**Garden City Design Review
Application Review**

**DSRFY2024-0002
34th Street Townhouses**

RESPONSE TO COMMENTS PER ARCHITECT 12/13/2023

DSRFY2024-0002

Trash Enclosure

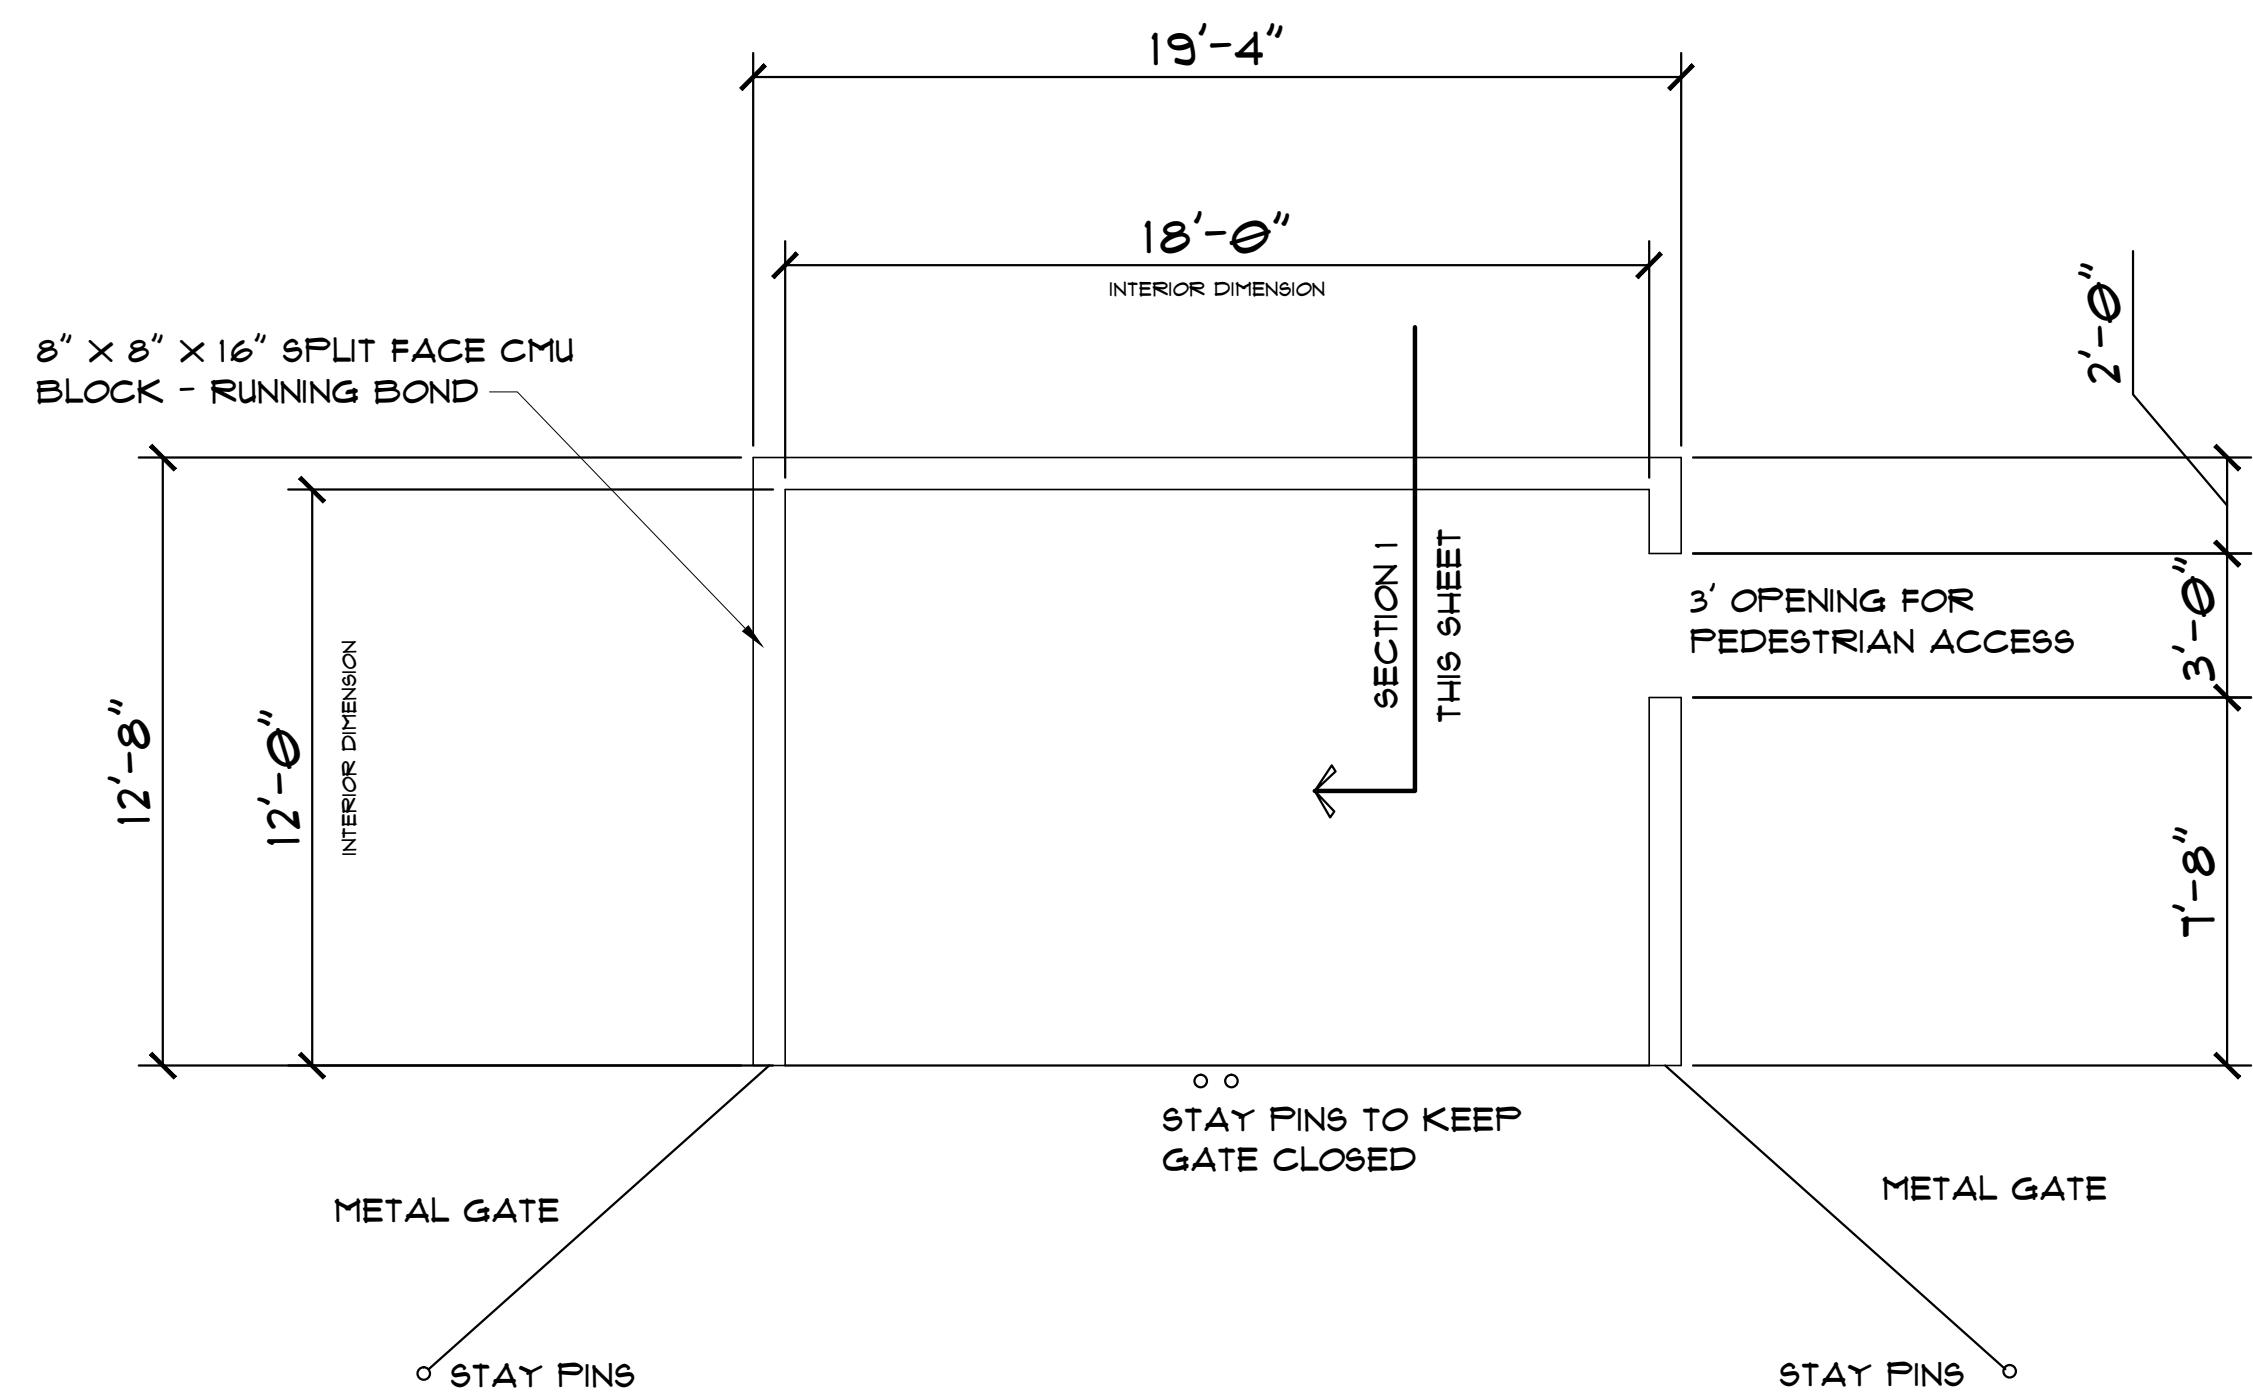
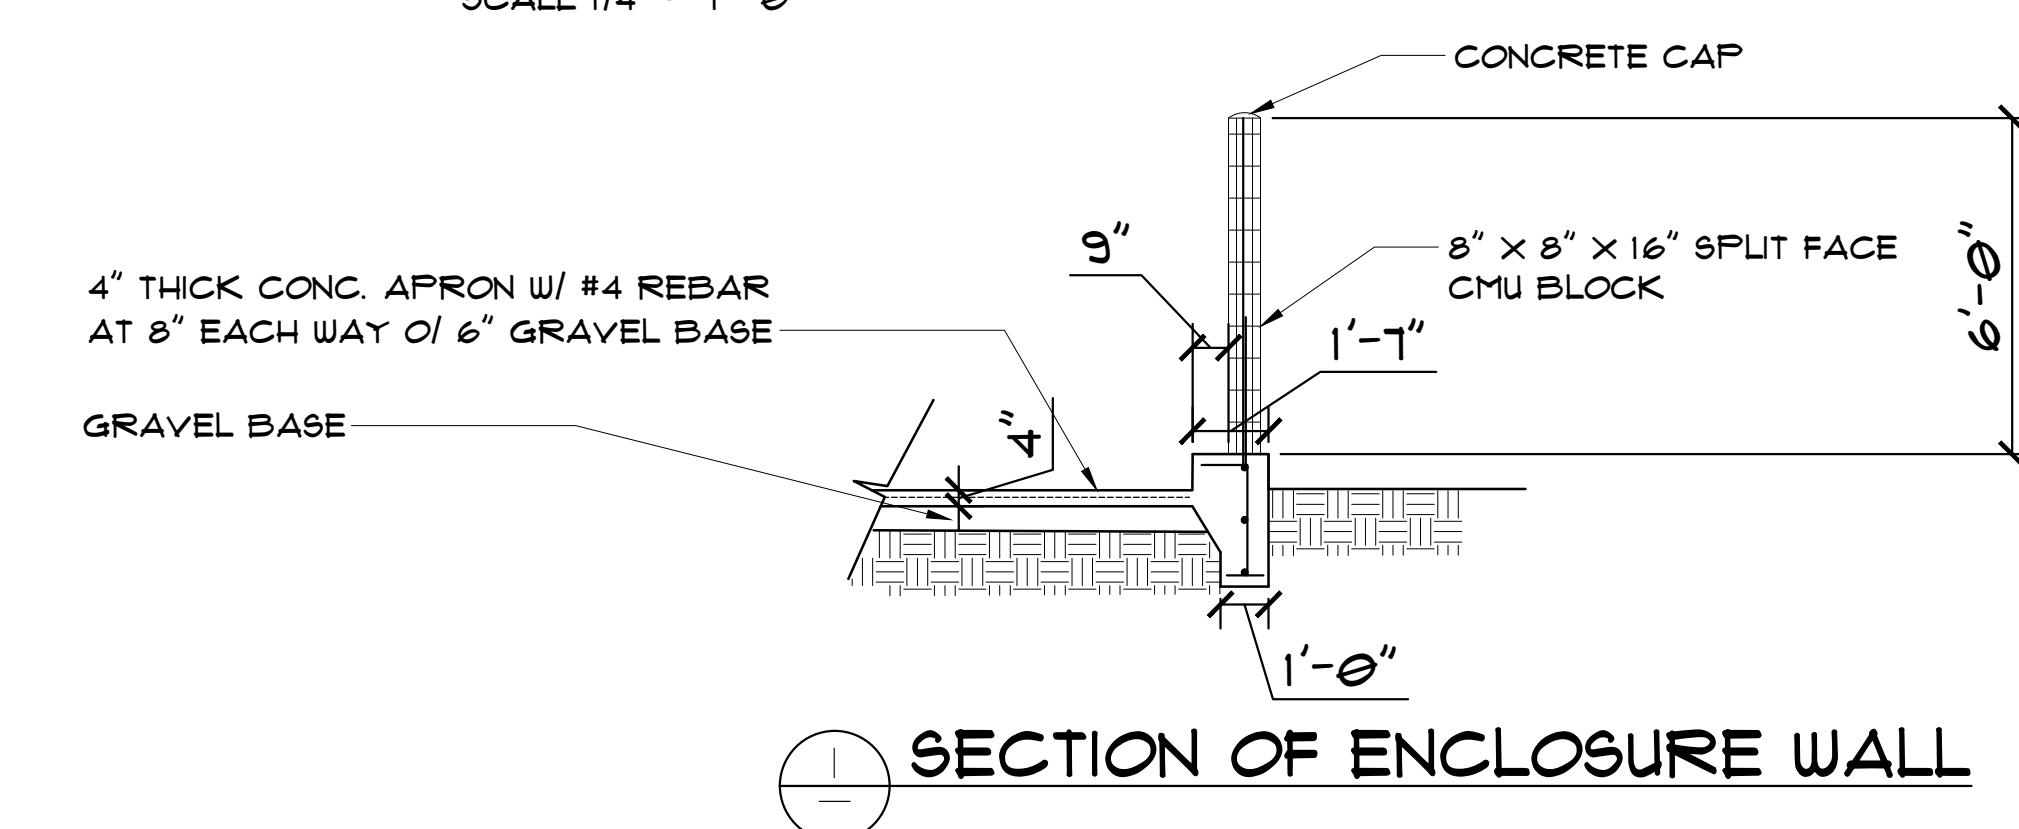
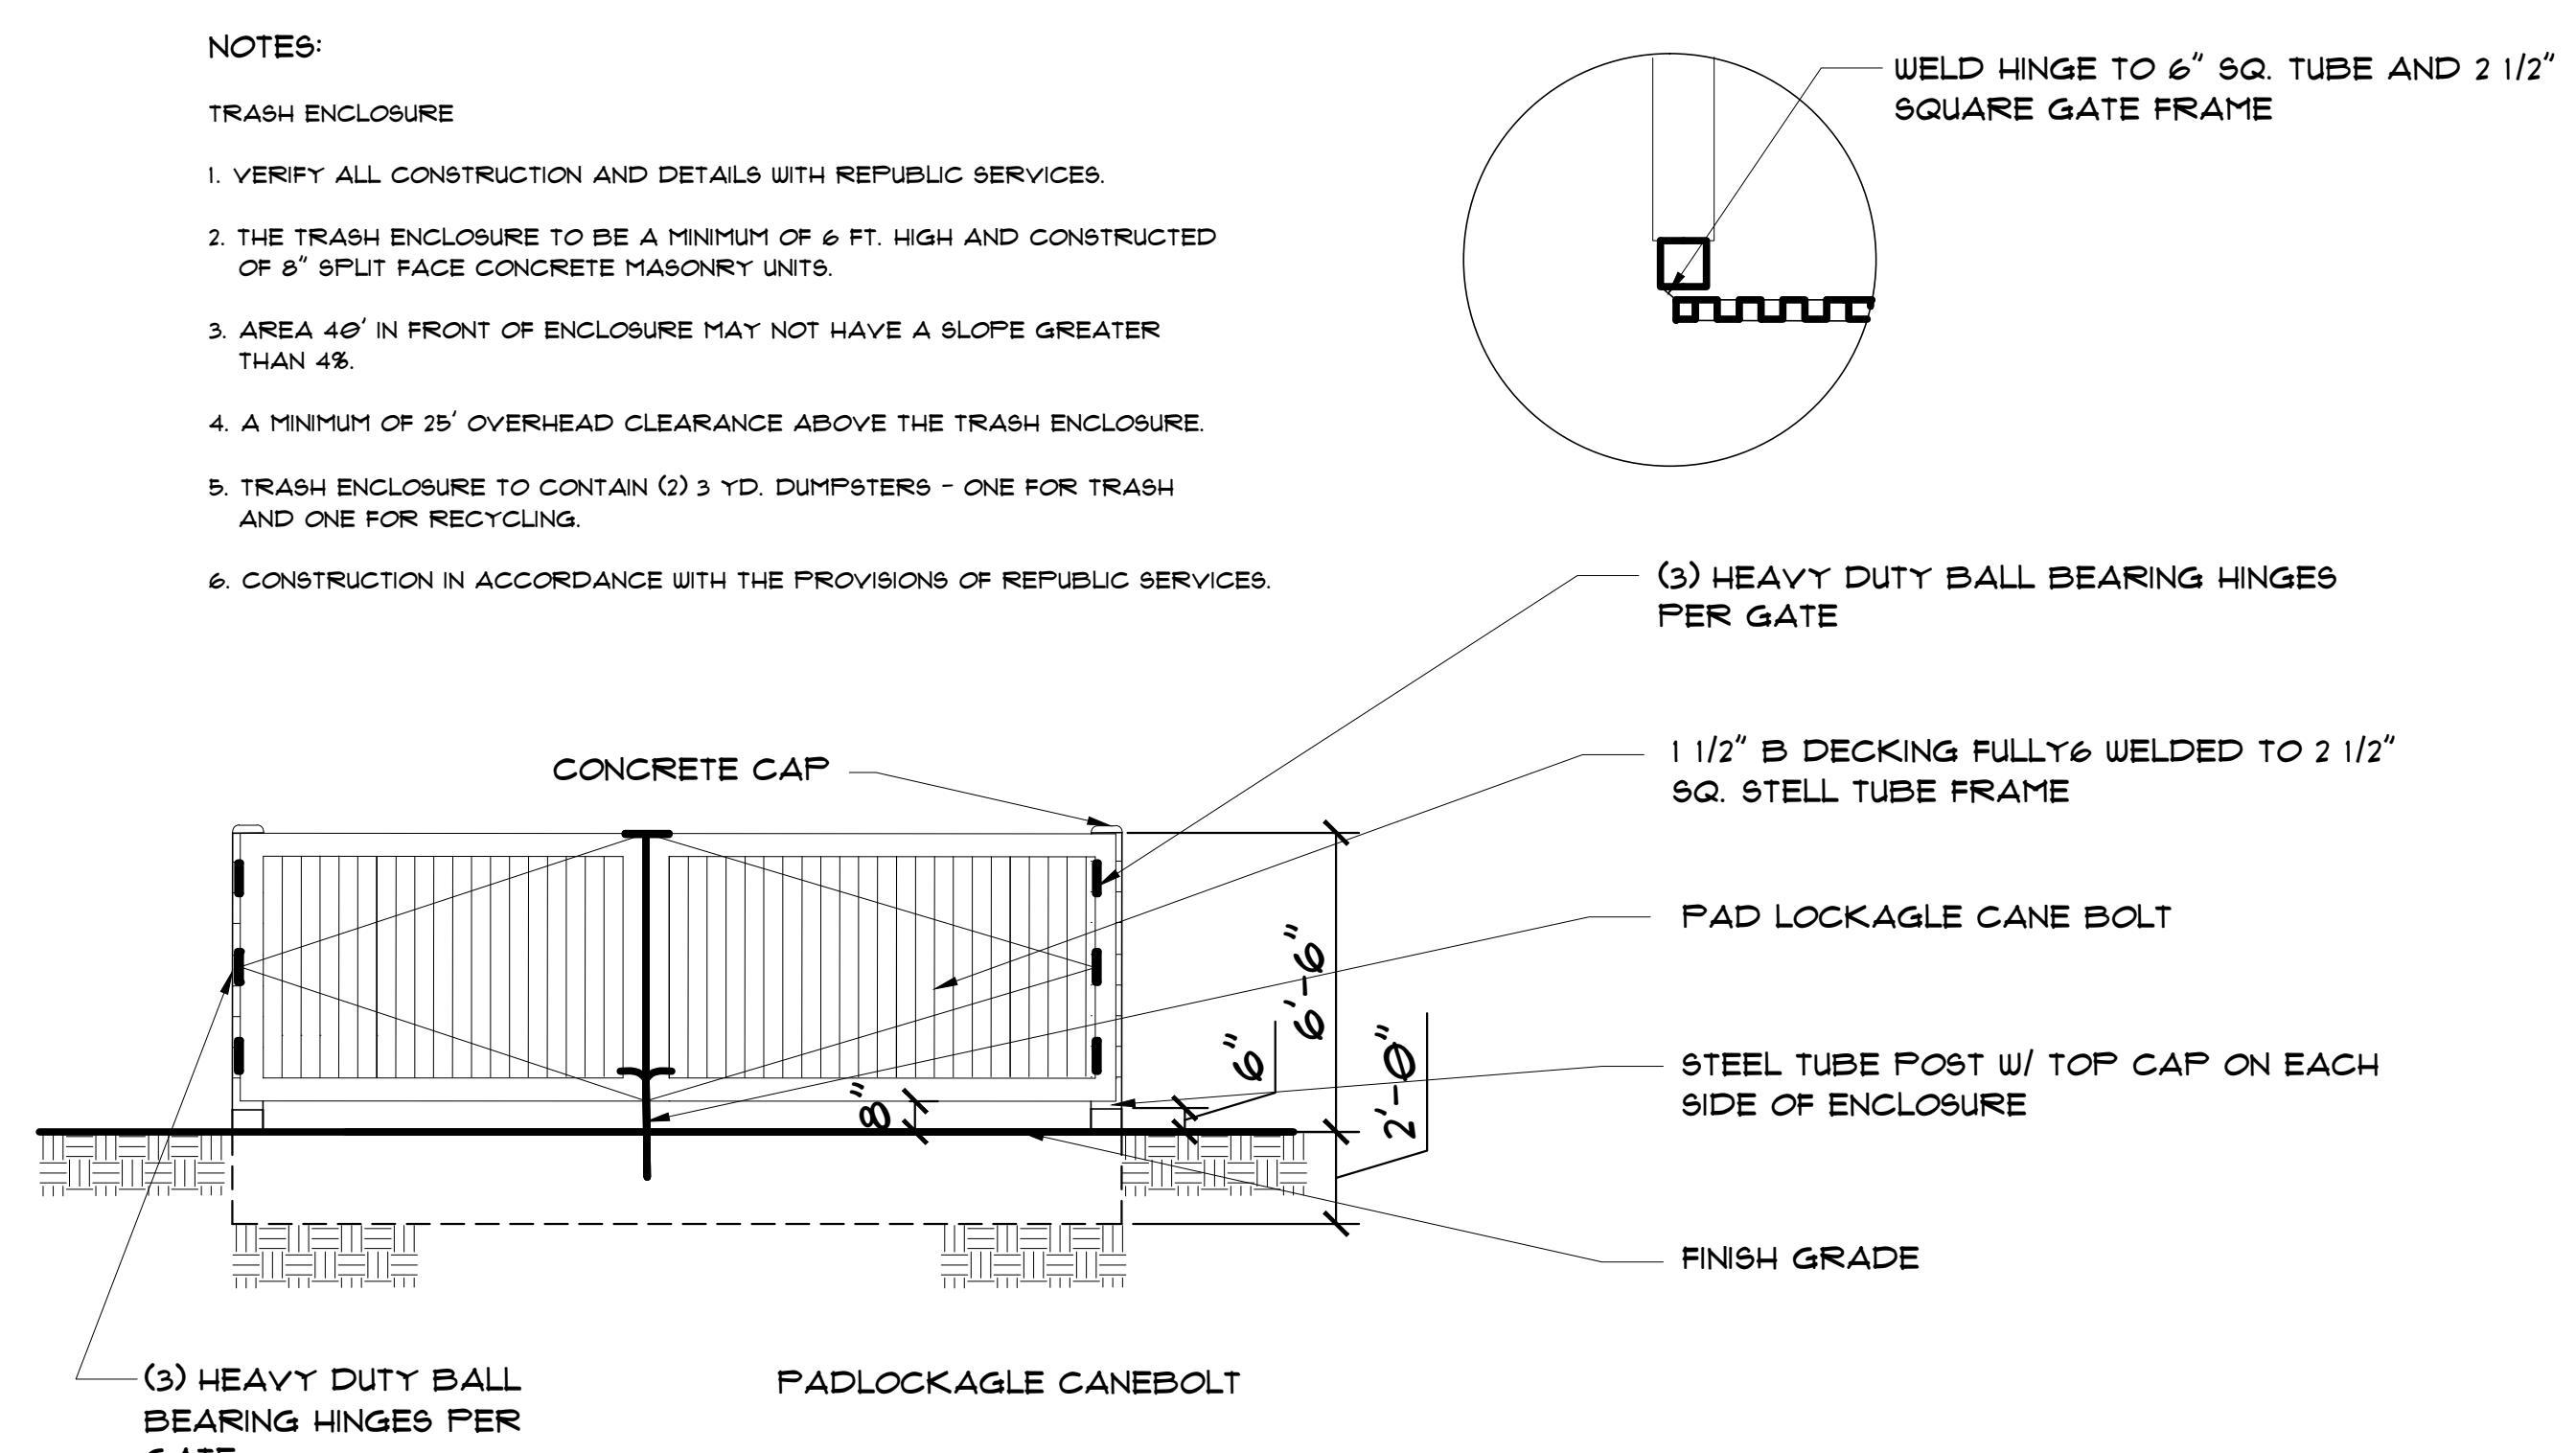
8. **Provide details/renderings/elevations of covered parking.** (TO BE PROVIDED BY MFGR. AND INSTALLER.)
9. **Provide details/renderings/elevations of trash enclosure & proposed screening.** (SEE SUBMITTED PLN. SHT.12)
